IN no.: **IN-141 rev 1.1**

Device affected: **nRF52840-QIAA and nRF52840-CKAA**

### Description of change:

The nRF52840 revision 3 (build code Fx0) introduces four changes to the product.

*Changes to pin-out:*

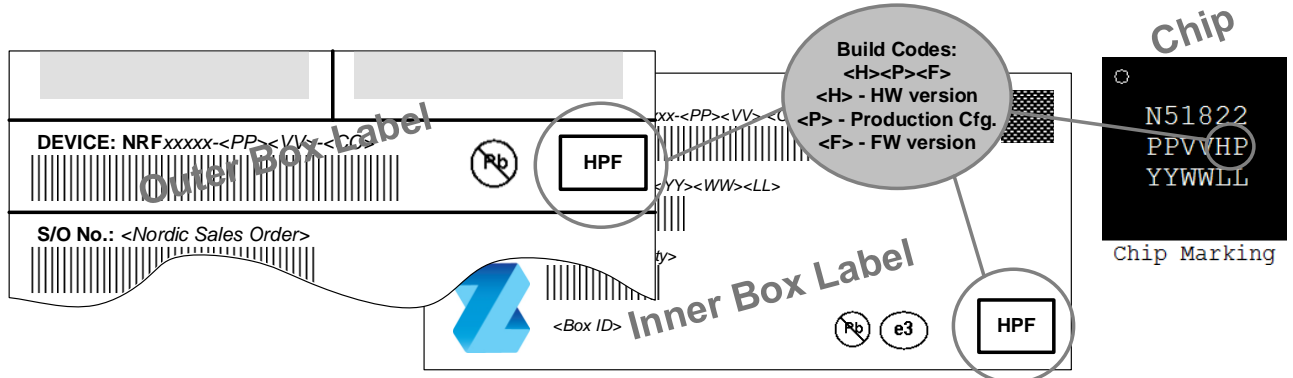
Existing PCB designs for the nRF52840 (rev. 2 and earlier) are compatible with the nRF52840 revision 3 without performance degradation. For new designs an updated bill of material for the reference schematic is available in the product specification rev. 1.5 or later. The new bill of material requires one less decoupling capacitor.

**Chips:**

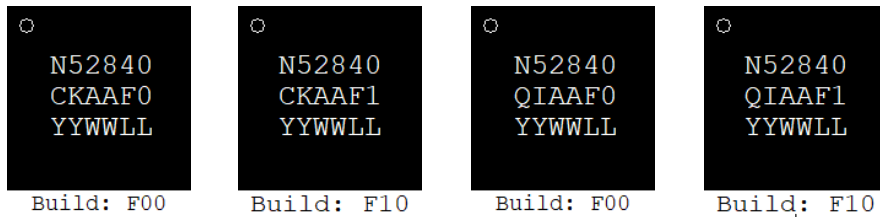
Build code – Fx0
